**FAIRCLOTH - GARAGE  
5244 COOL SPRINGS RD  
BROADWAY, NORTH CAROLINA**

**FOUNDATION PLAN**

**ENGINEERED SUBMITTAL**  
 This submittal has been reviewed for specified design criteria & compatibility with building structure. The design of these components is the responsibility of those providing the components.  
 HMHendrick Enterprises, Inc.  
 By: **HMH** Date: **09/30/25**

**Johnny Faircloth**  
**Garage**  
**ROOF PLACEMENT PLAN**

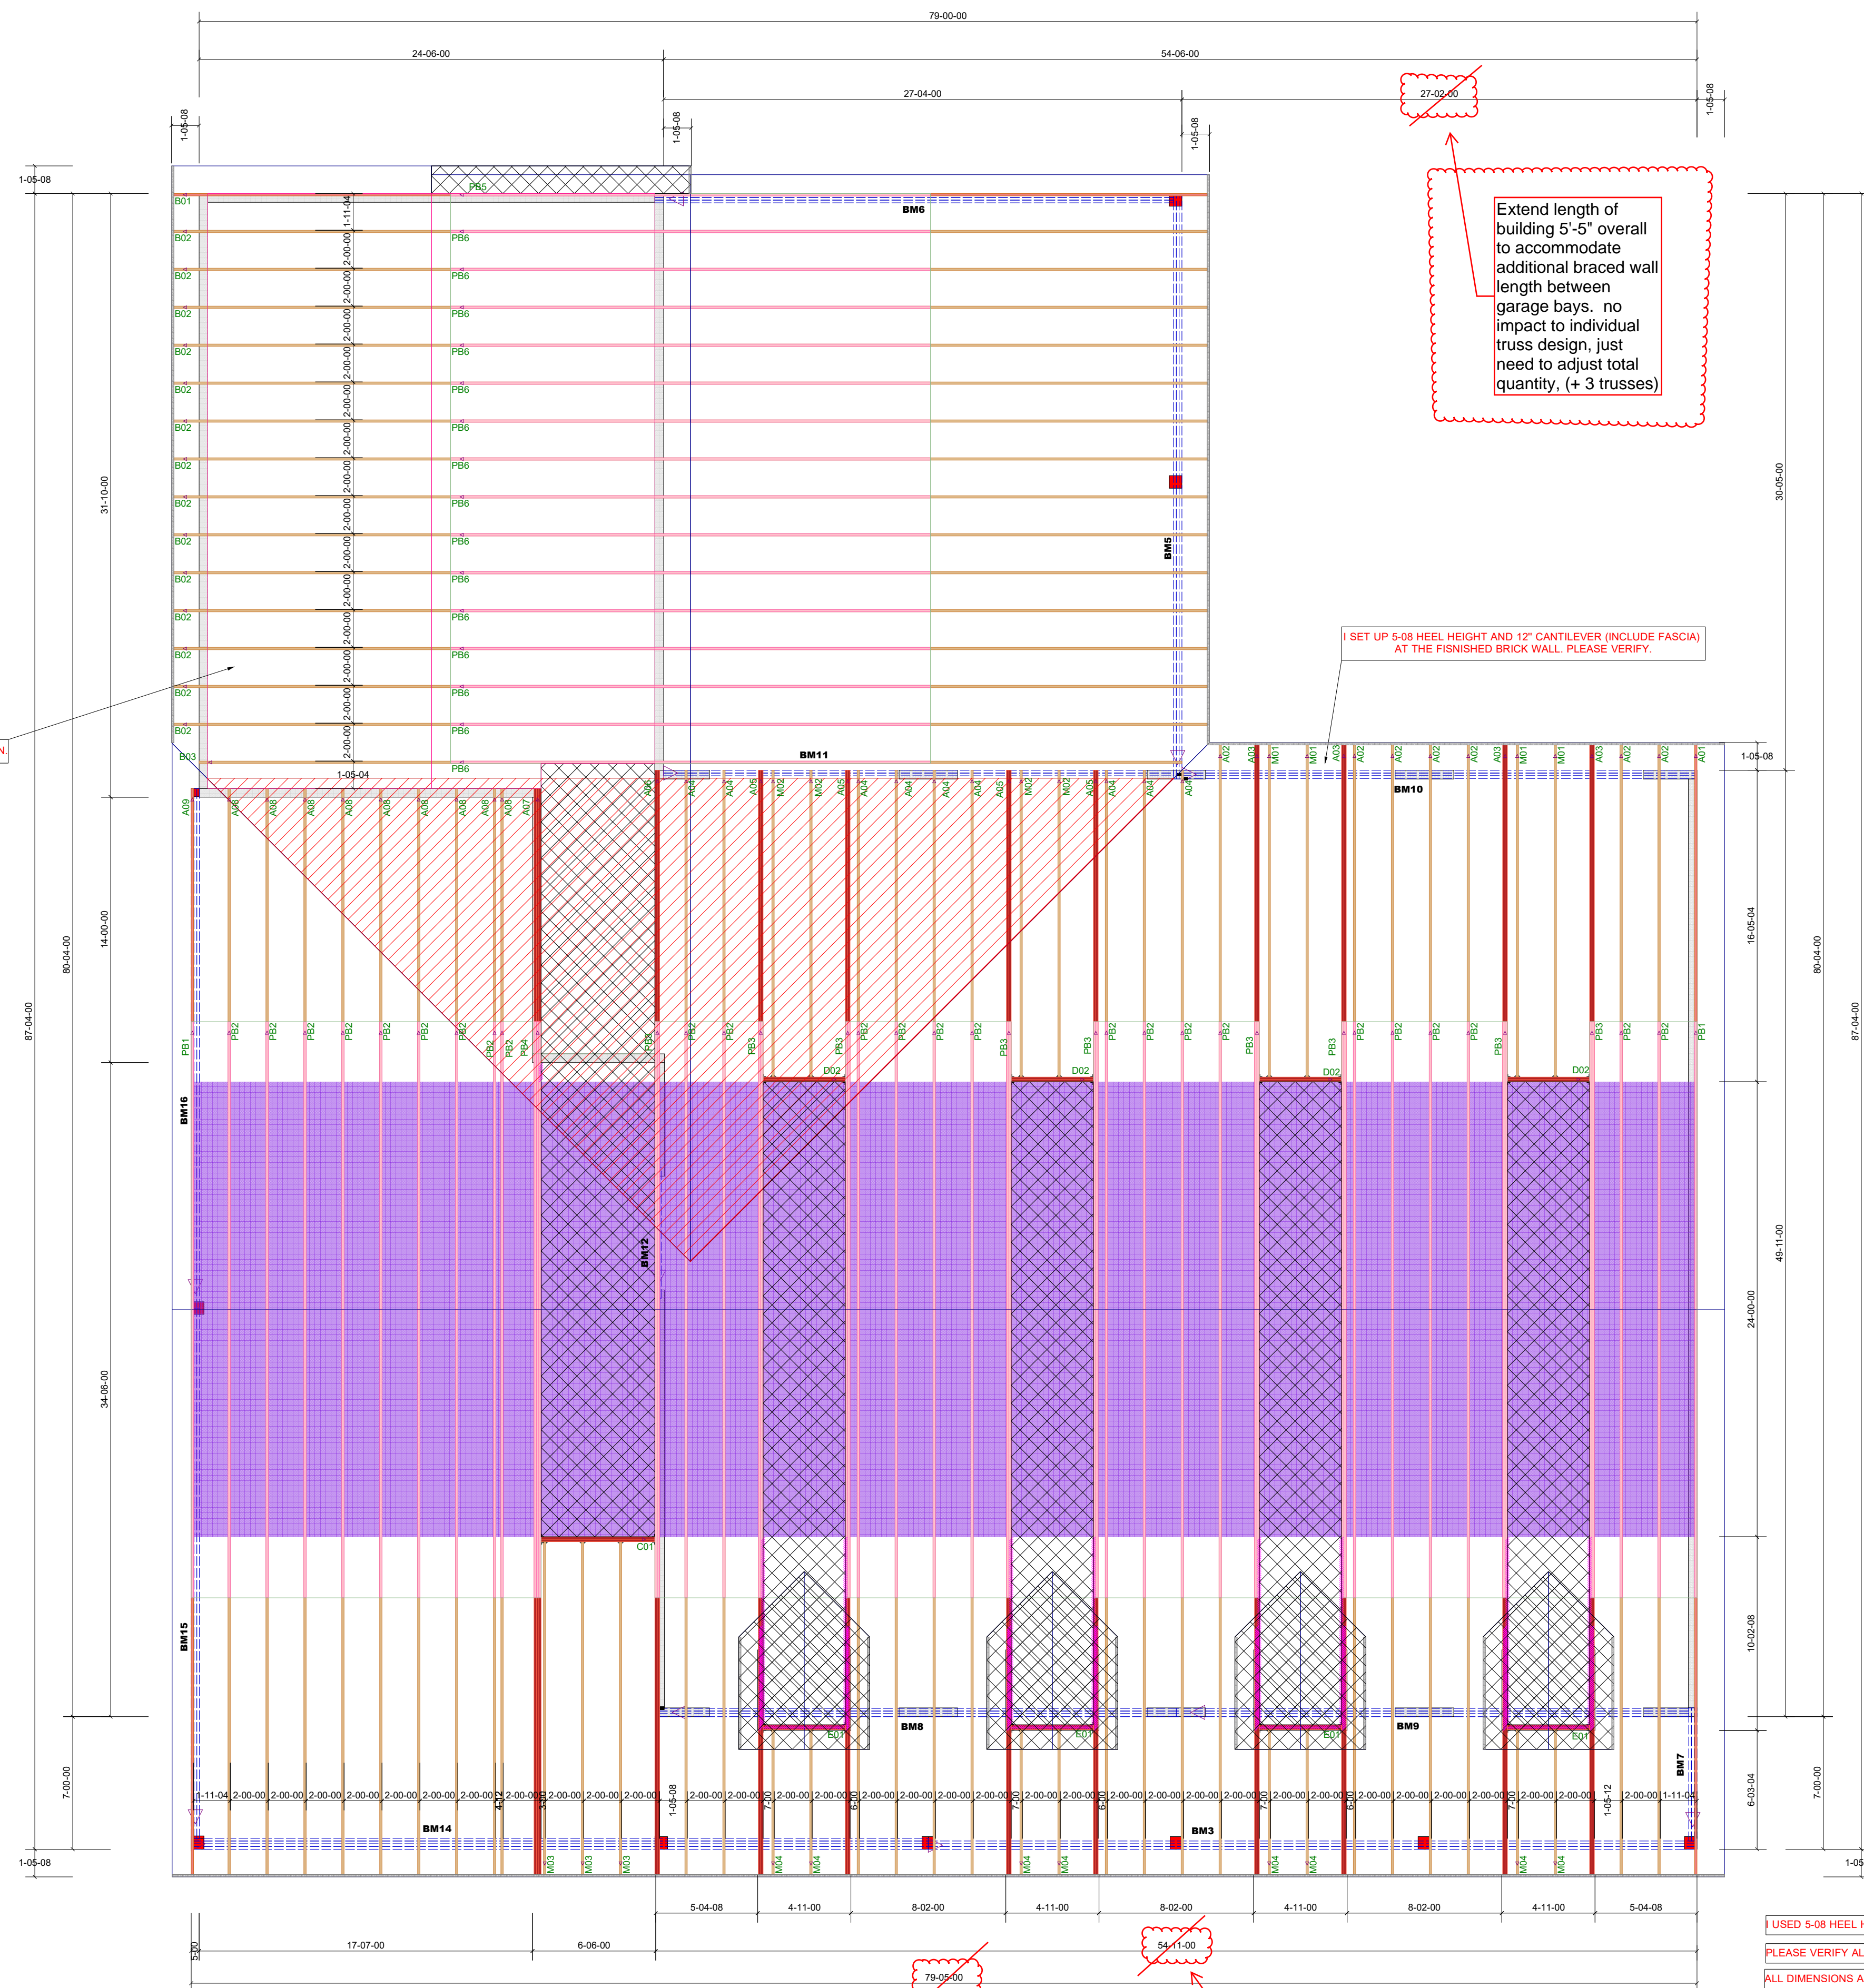
PLEASE VERIFY 5/12 SLOPE FOR CATHEDRAL CEILING IN THE 1ST FLOOR KITCHEN

Extend length of building 5'-5" overall to accommodate additional braced wall length between garage bays. no impact to individual truss design, just need to adjust total quantity, (+ 3 trusses)

SET UP 5-08 HEEL HEIGHT AND 12" CANTILEVER (INCLUDE FASCIA) AT THE FINISHED BRICK WALL. PLEASE VERIFY.

Truss package engineering package as prepared by Carter Lumber, and sealed by their engineer, (Mr. Eric A. Gilbert, PE) was reviewed for compliance with building layout and assumed loading/load-path, and found to be acceptable for the intended construction.
